RE: Proposed S4.55(1A) Application for the Modification of Consent SSD 8019 – Proposed Minor Design Changes and Amendment to Conditions of Consent – 21 Honeysuckle Drive, Newcastle NSW 2300

KDC Pty Ltd (KDC) acts on behalf of its client DOMA Group (DOMA) in lodging this s4.55(1A) application to the Department of Planning, Industry and Environment (the Department) for minor changes to the approved architectural plans and conditions of consent (Condition B16 and Condition B17) relating to SSD 8019, being a mixed-use development located at 21 Honeysuckle Drive, Newcastle NSW 2300.

Figure 3 – Proposed Basement Level (Source: SJB)

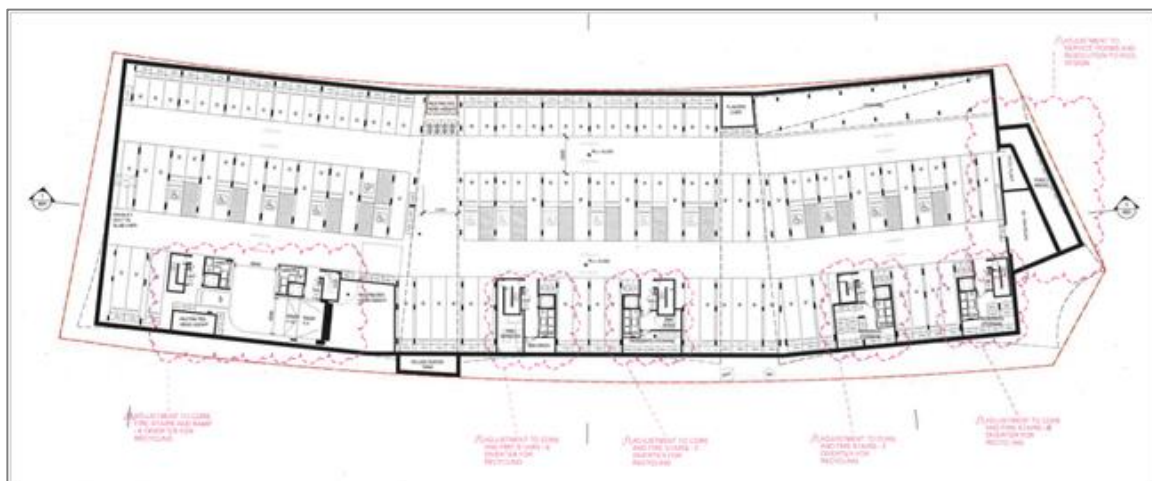
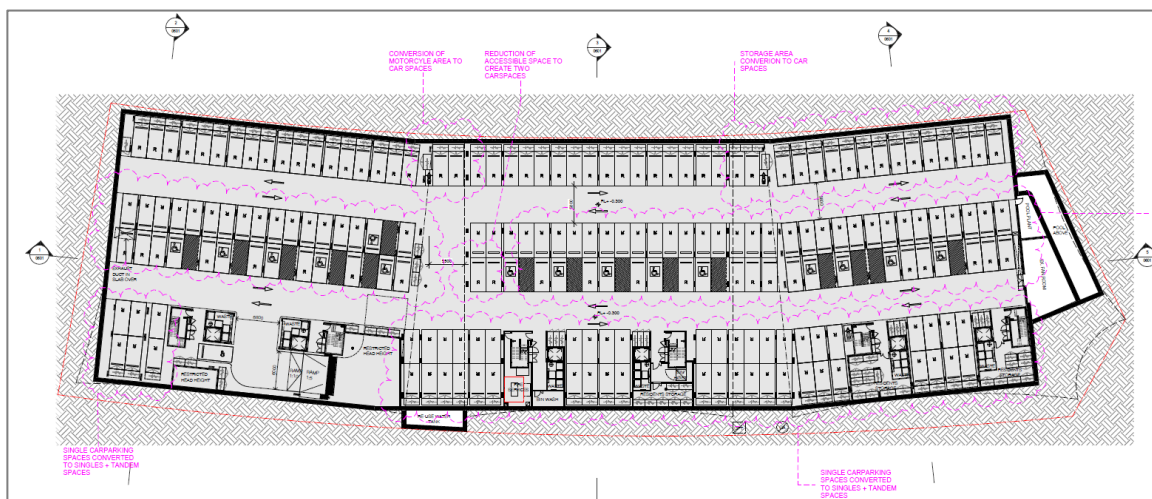
Level	Proposed Modification	Reasoning for Changes	Impact of Change
Basement Level	+ Amendments to carparking layout including conversion of storage to carparking.	+ Detailed design phase revealed opportunities to be more efficient with space and provide additional parking to meet the consumer demand. All additional carparking will be allocated to residential apartments.	+ The modifications at basement level result in increase to floor space ratio (FSR) due to the requirement for surplus parking to be included in gross floor area (GFA). Overall, the impact of change is considered to be negligible, given the bulk and scale of the development will not change as a result of the additional GFA in the basement level.
Ground Level	+ Minor amendments to carparking configuration for the terraces and visitor carparking. + Revision of bicycle parking.	+ Detailed design phase revealed opportunities to be more efficient with space and provide additional parking to meet the consumer demand. + Detailed design phase revealed opportunities to improve the location of the bicycle spaces and be aligned with the Newcastle Development Control Plan 2012.	+ Minimal impact as on ground level one additional parking space is proposed and bicycle parking will be compliant with the Newcastle Development Control Plan 2012 and be highly accessible. The relocation of the visitor and commercial bicycle spaces from internal to external to the building results in a better outcome, as the bicycle spaces are

Level	Proposed Modification	Reasoning for Changes	Impact of Change
			positioned in a highly accessible location in comparison to the previously approved (MOD 1). It is also proposed to convert one visitor car space to a residential space to align with the DCP.

Figure 2 and Figure 3 compare the basement level from the approved arrangement to the proposed sought under this modification.
